**Public Submission**

**Jupiter Wind Farm EIS**

**Residence J234A / J234B**

Date: 5 February 2017

Figure 10: Extract from AEMO / TransGrid Project Assessment Report, 2014

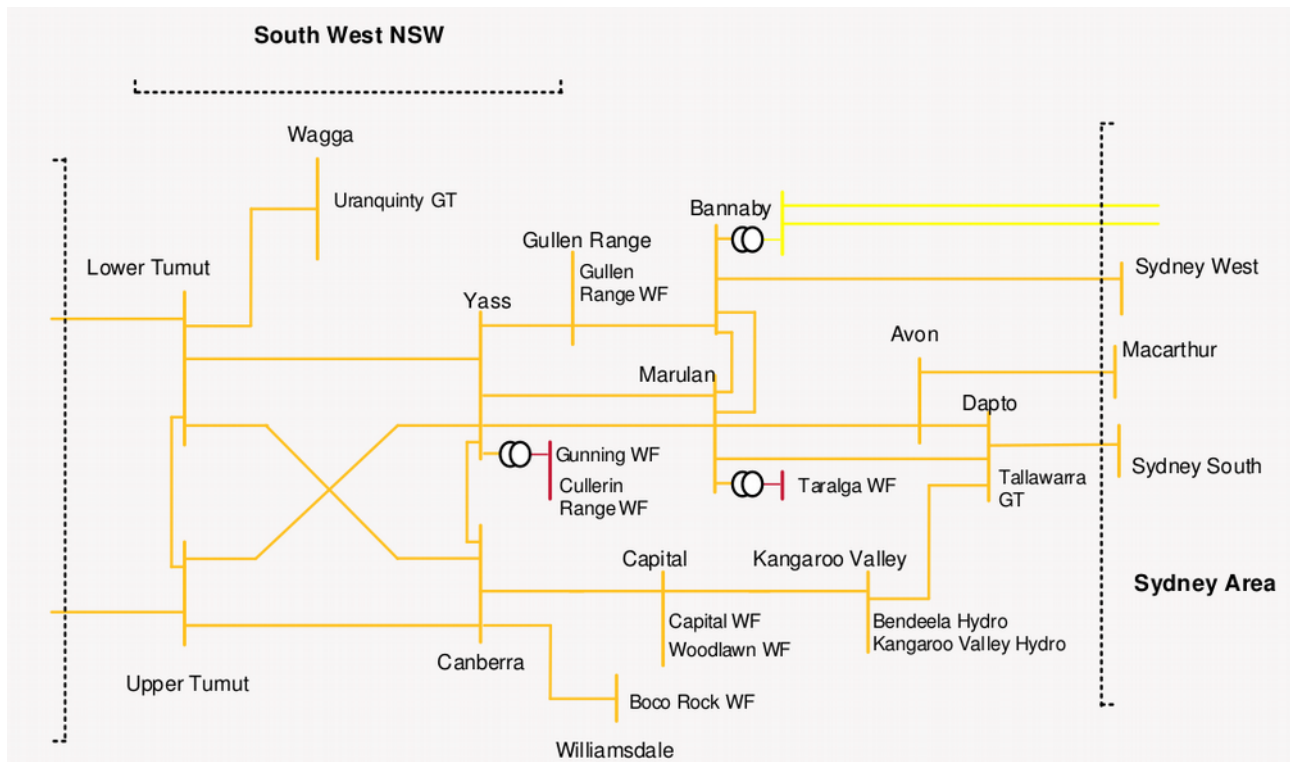
The Jupiter Wind Farm is identified in relation to the TransGrid Project Assessment Reports, however it's capacity is not listed. Figure 10 (extracted from the report) shows the Snowy region to Sydney transmission network. They also list an additional 1958.4 MW of intermittent generation capacity (wind and solar) announced (in 2014) to be added in this region. While dynamic line ratings (adjusting the line capacity based on weather conditions) may alleviate the network congestion (particularly during high wind generation), the problem will remain as the intermittent generation capacity is increased.

**Rejection 5:** *The Jupiter Wind Farm proposal should be rejected. Significant additional capacity that has now been approved in the transmission lines between the Snowy region and Sydney. This will likely lead to electricity network congestion once operational. Although dynamic line ratings may alleviate this congestion, the investment associated with the Jupiter Wind Farm would be better placed in another geographical area less likely to lead to network congestion.*

Figure 35: High levels of activity right before and during breeding period (October/November)

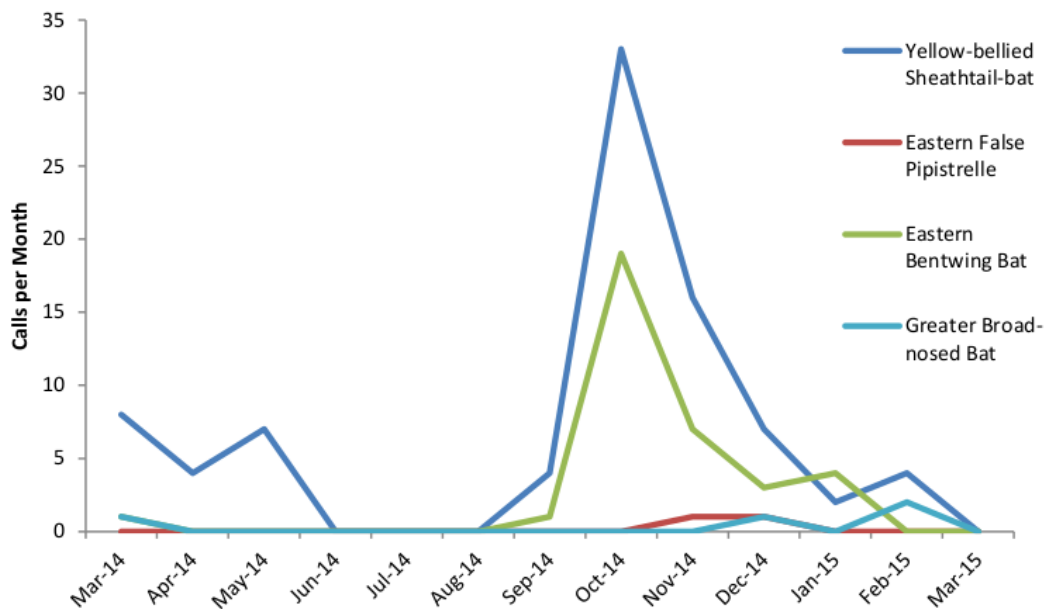
EPYC and ERM highlight the Eastern Bentwing Bat congregates in maternity caves between November and February. While the Mount Fairy cave has been called a 'staging' cave in many sources, data collected from mast mounted bat detectors for the Jupiter Wind Farm demonstrate a very high level of activity peaking in October and continuing through till February (Figure 35). They also highlight the lack of calls from mast mounted units in the migratory period in March.

It is entirely possible the existing knowledge in relation to the Mount Fairy cave is incorrect. If the cave is not being used for migratory purposes (there was a lack of activity to identify this), and there is a higher level of activity from October to February, then the cave may be used for breeding. This possibility has been overlooked by EPYC and ERM. A peak in October and November may be the migration to the cave for breeding.

Figure 39: Kalbilli Group of turbines (Square on bottom left represents cave)

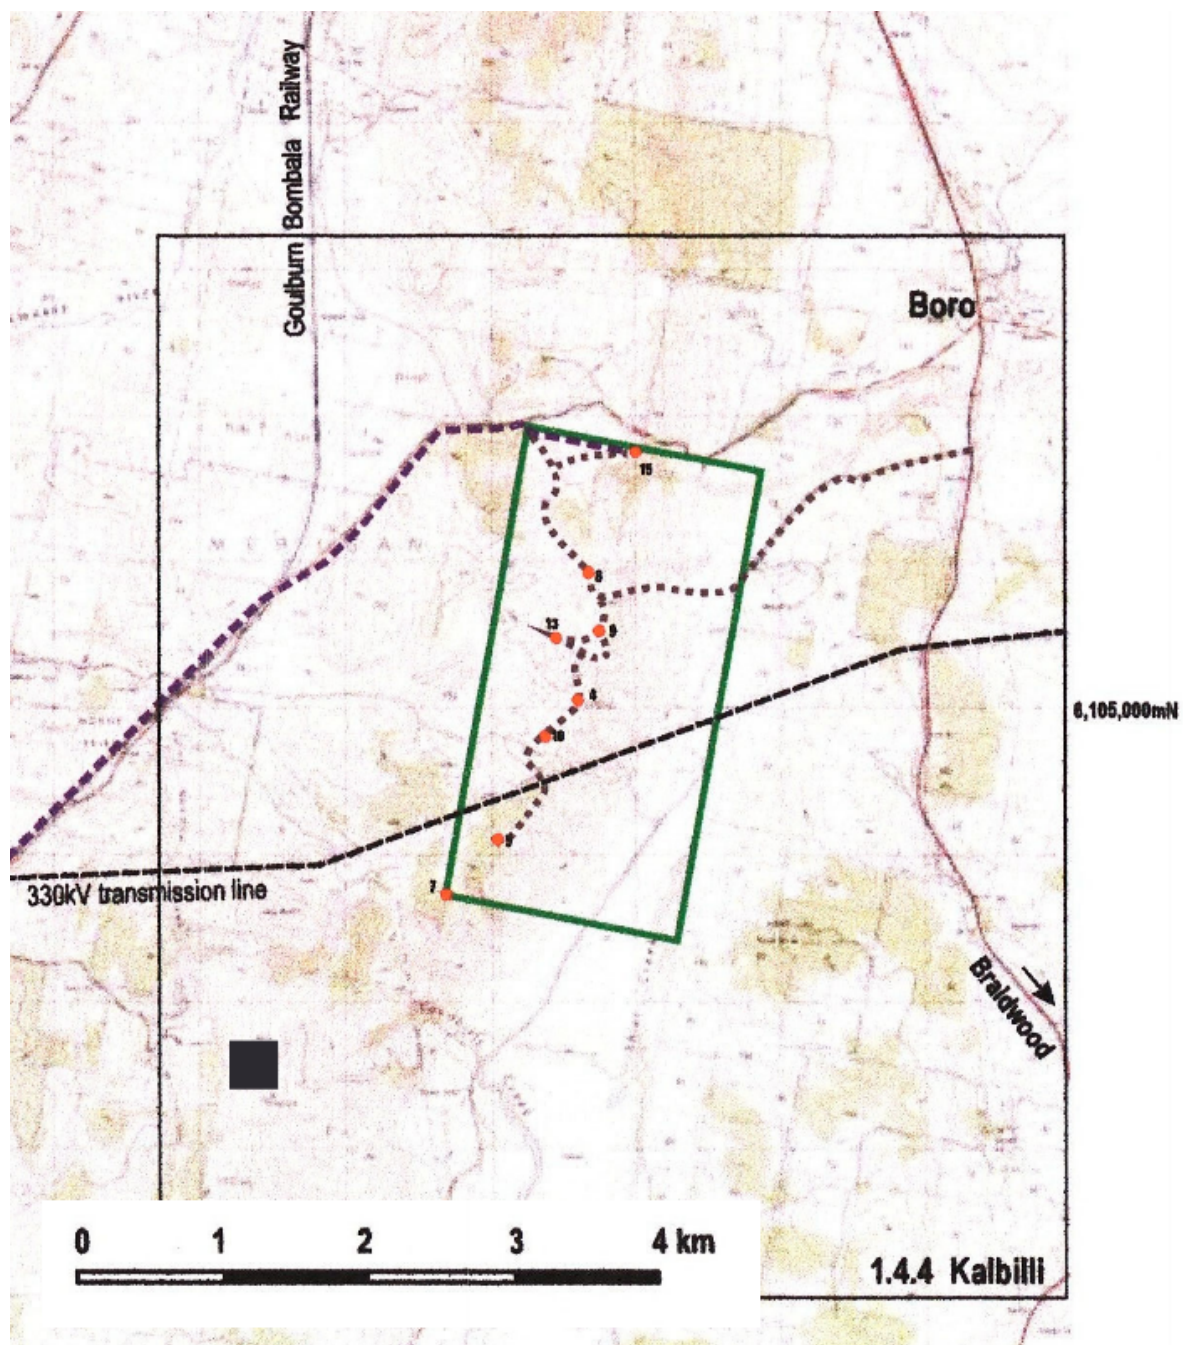
The Bat Survey for the Capital Wind Farm highlights a fourth group of WTGs (the Kalbilli Group) was removed from the project. These turbines were in very close proximity to the cave at Mount Fairy (Figure 39, from Appendix G2 Bat Survey Jun 2005 of the Capital Wind Farm proposal). No direct basis is provided for the removal of these wind turbines in the report, however the report does highlight concern for the conservation of the Eastern Bentwing Bat if the Kabilli Group had been included (Figure 38).

A significant aspect of this report is the results of data collected from sites 1, 2 and 3 (within the project area), and site 4 (at the Kalbilli Group site). Almost 2600 bat calls were detected at the Kalbilli Group site over a period of three (3) nights. Eighty-one of these calls were of the Eastern Bentwing Bat (Table 20).

Figure 40: Potential migration paths following waterways

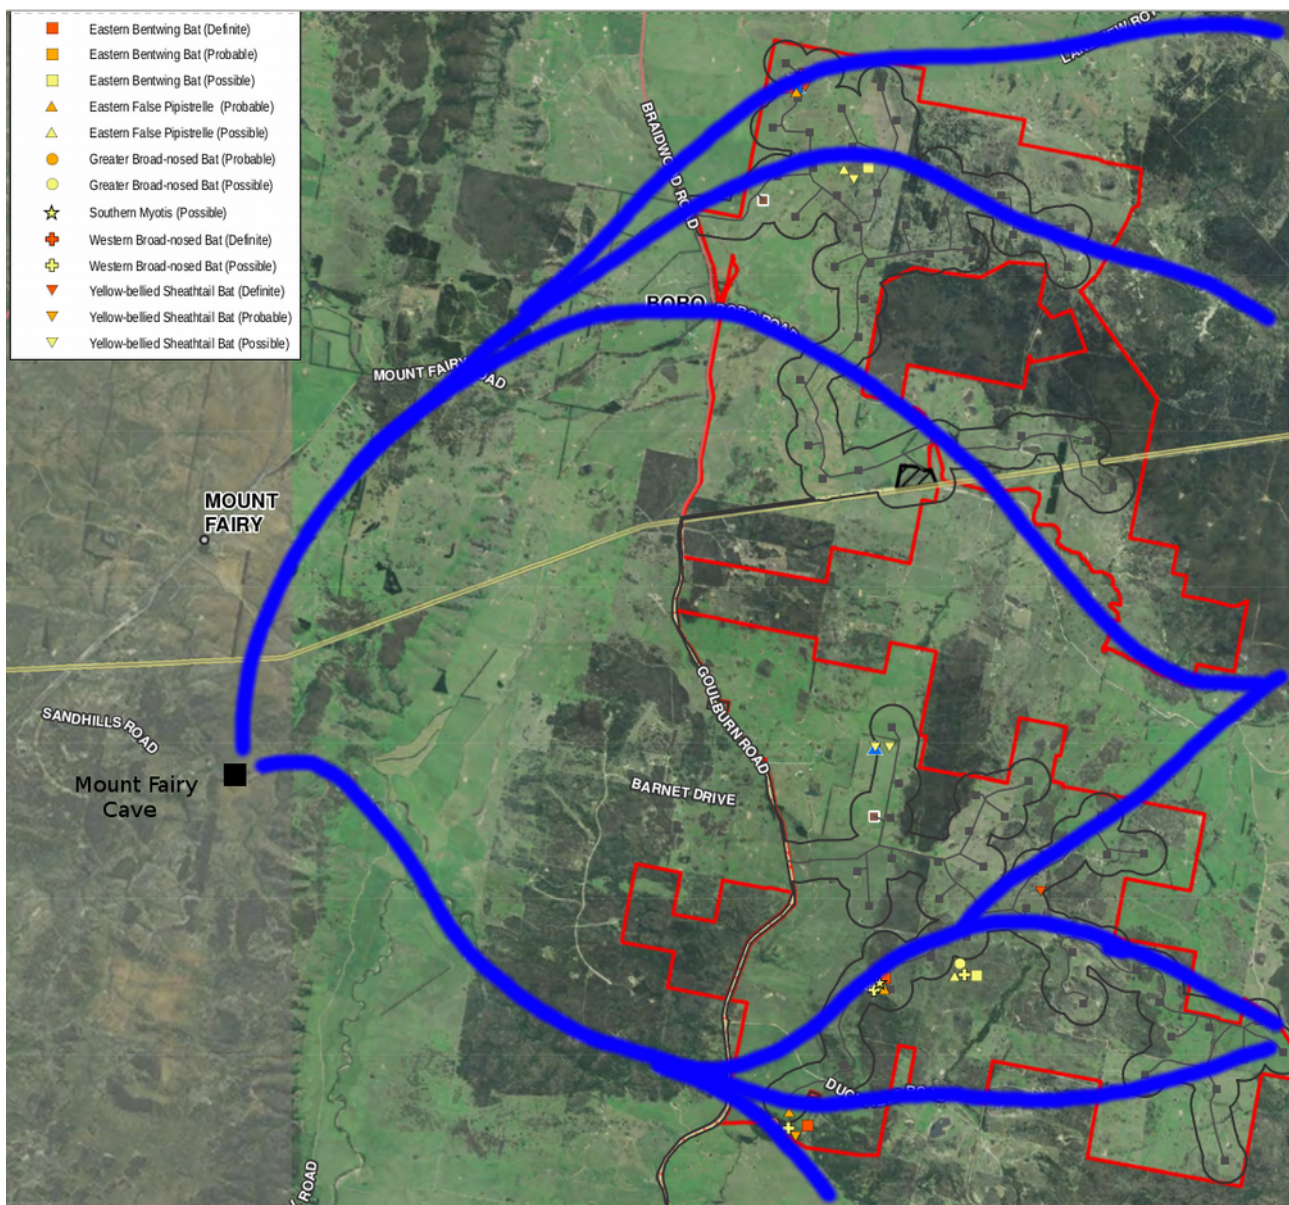
Figure 40 shows potential migration paths based on watercourses in the area and detection of the Eastern Bentwing Bat. Such a scenario shows the bats will likely be passing through large portions of the Jupiter Wind Farm northern precinct.

**Rejection 68:** *The Jupiter Wind Farm should be rejected. Potential migratory paths to the coast following waterways pass through large portions of the northern precinct of the wind farm.*

Figure 41: Potential foraging paths through the Jupiter Wind Farm

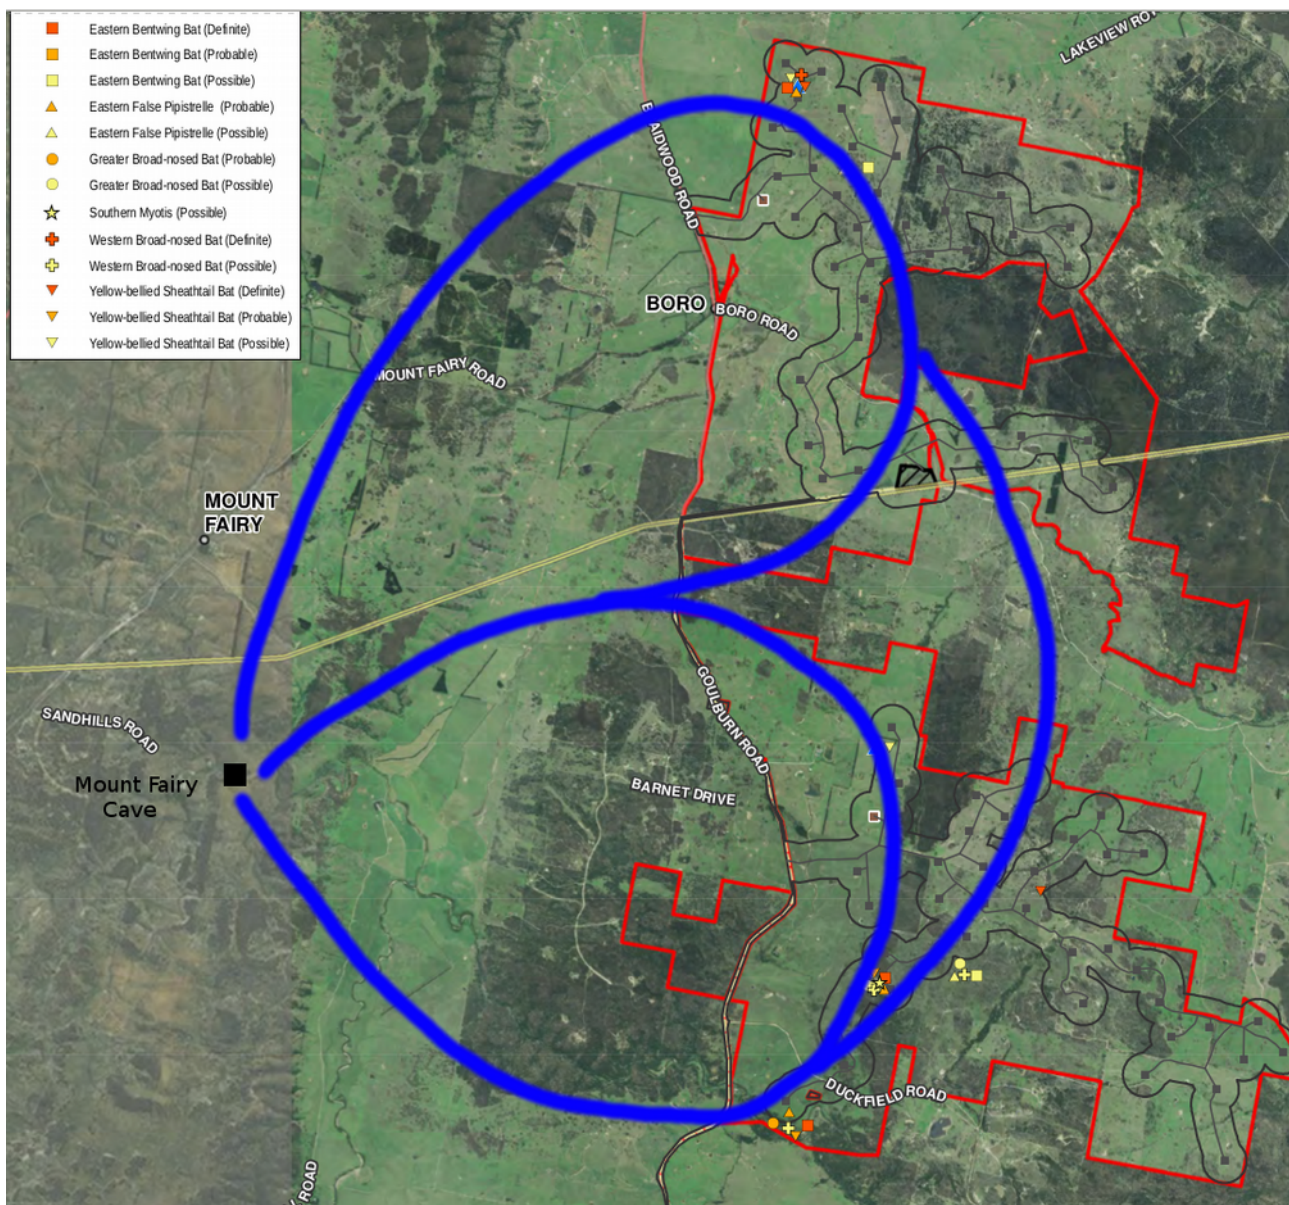
Figure 41 contains potential foraging paths around the Mount Fairy Cave. The shorter paths are approximately 18kms, and the longer path approximately 35kms. These paths are well within the range and capability of the Eastern Bentwing Bat. Under such a scenario, a large portion of the bat population will pass through the Jupiter Wind Farm.

Figure 42: Valley acting as funnel for noise for J234A and J234B

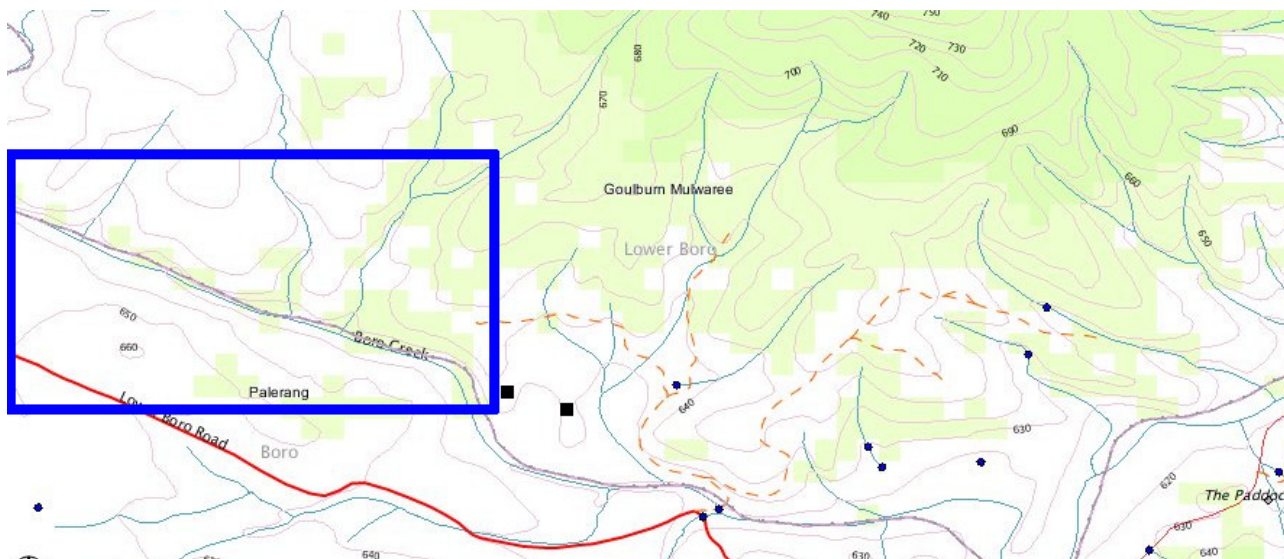
On the North West side of J234A and J234B is a valley through which Boro Creek passes through. This valley acts as a funnel for sound on the property. Throughout the year we are able to hear vehicles passing on the Goulburn – Braidwood road, including the summer periods. The terrain features here (Figure 42) include:

- At least two kilometers in length leading directly up to J234A and J234B;
- The valley aligns with the prevailing wind direction;
- Sides of the valley can exceed 30m in some locations; and
- A significant number of wind turbines will be located at the other end of this valley.

Several studies have shown certain terrain shapes can focus sound. For example Tonin<sup>20</sup> states in “Sources of Wind Turbine Noise and Sound Propagation” that one of the factors “affecting sound propagation [is] ... Shape of the land (certain land forms can focus sound)”.

*Figure 47: Colour adjustment demonstrates deceptive nature of photomontages*

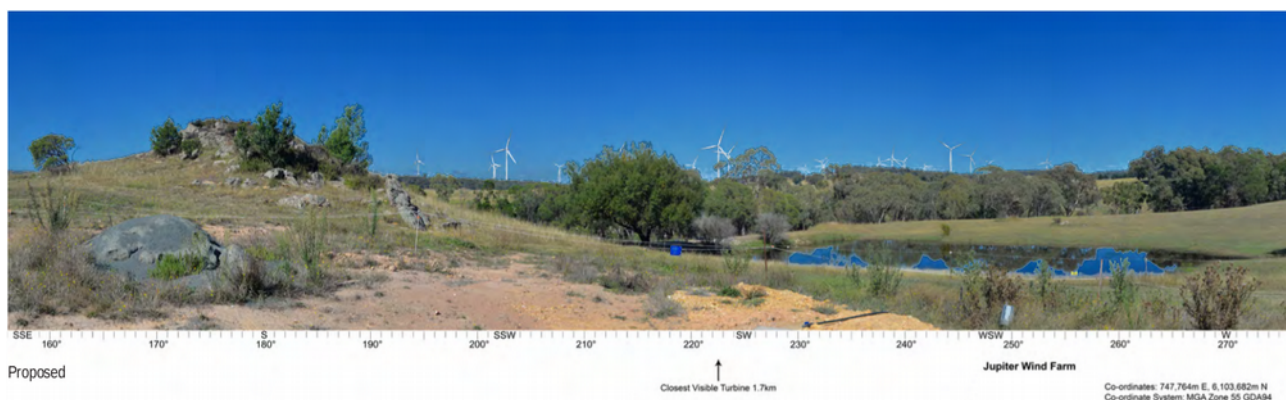
When the colours are adjusted to be a darker blue on the horizon, it is clear the turbines become a very clear and dominant feature of the landscape. Figure 47 contains an example of the adjusted image in which the turbines do not actually blend into a pale blue/white colour on the horizon.

The proponent EPYC and Clouston Associates will likely argue this image is not representative of the view. Over a period of multiple days, photos were taken from Mount Fairy Road, approximately 1.7kms from existing wind turbines. Figure 48 contains a photo taken from approximately 5kms, and Figure 49 contains a photo taken from approximately 2kms away. Photos from an existing wind farm clearly show a distinction between the turbine itself and the sky.

*Figure 56: Sunset view from J234A*

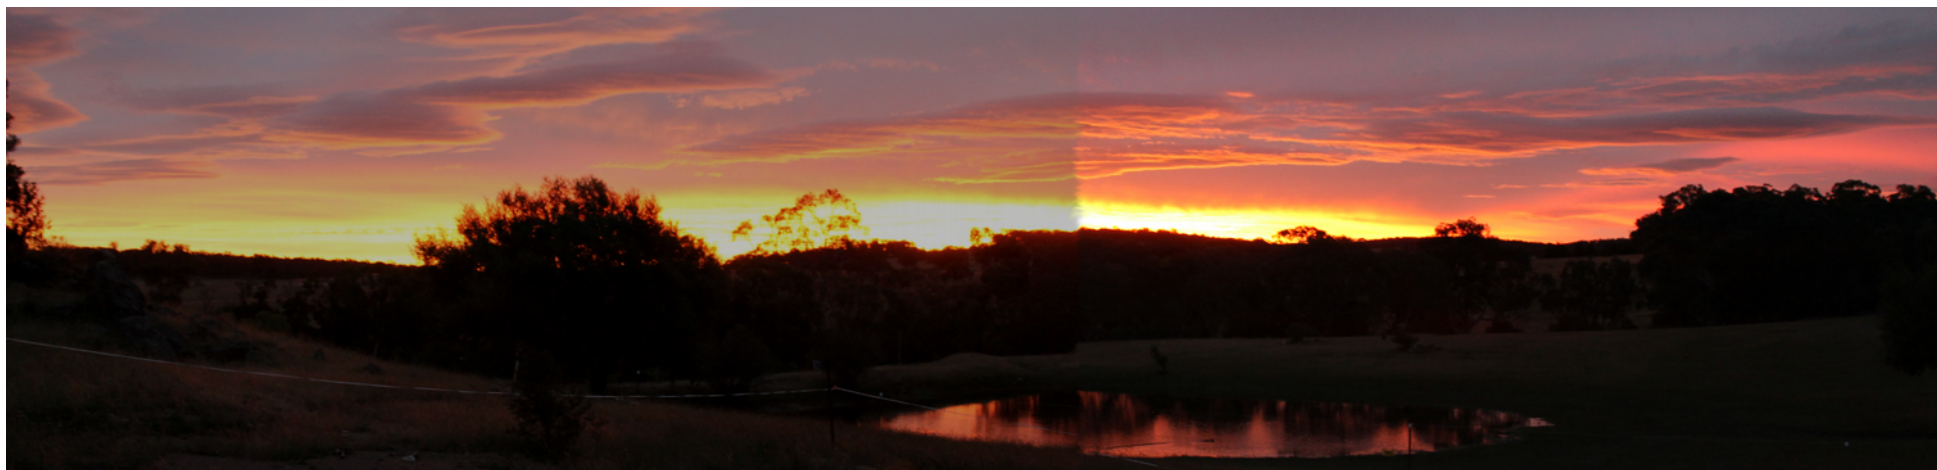
Figure 56 and Figure 57 contain the original sunset view, and the superimposed wind farm image. The Jupiter Wind Farm clearly dominates the landscape and scenic view.

Figure 58: Google Earth image showing J234A to WTGs 4, 6 and 32

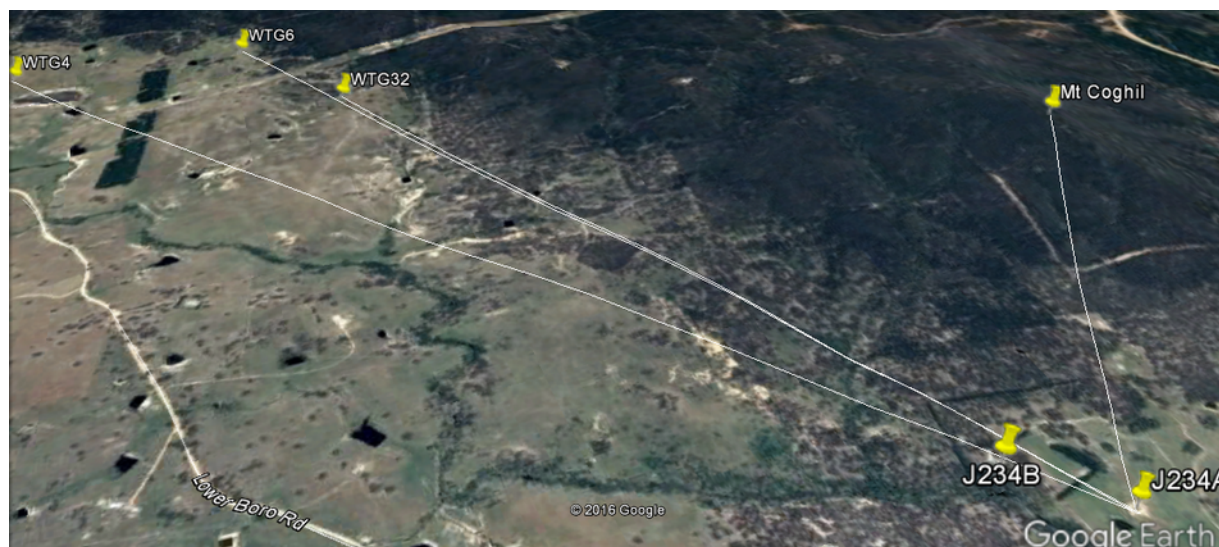
Using Google Earth, WTG4, WTG6 and WTG32 were plotted on a map (Figure 58). Paths were then plotted from J234A to each of these WTGs, and a terrain profile was developed (Figure 59). From the terrain profile, peaks in the terrain were identified, and basic high school trigonometry was applied to check angles to see if the WTGs would be visible. An additional 7m was added to each terrain peak to account for trees that might obscure the view.

Figure 61: Directions of turbines within 8kms from J234A

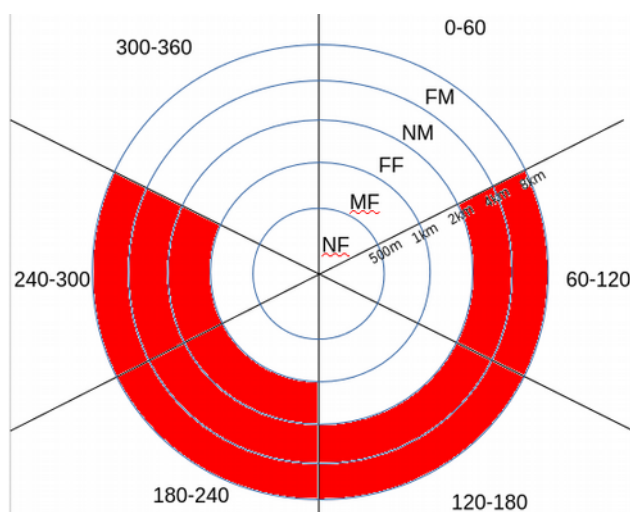
Figure 61 contains a summary of the directions of 74 turbines within 8kms of J234A. Within 2kms, around 120 degrees of the view will be taken up. Within 4kms, 240 degrees will be taken up with a view of turbines. Although not all of these turbines will be visible from the same location on the property, as we move around the property the turbines will be a dominant feature of the surrounding landscape.
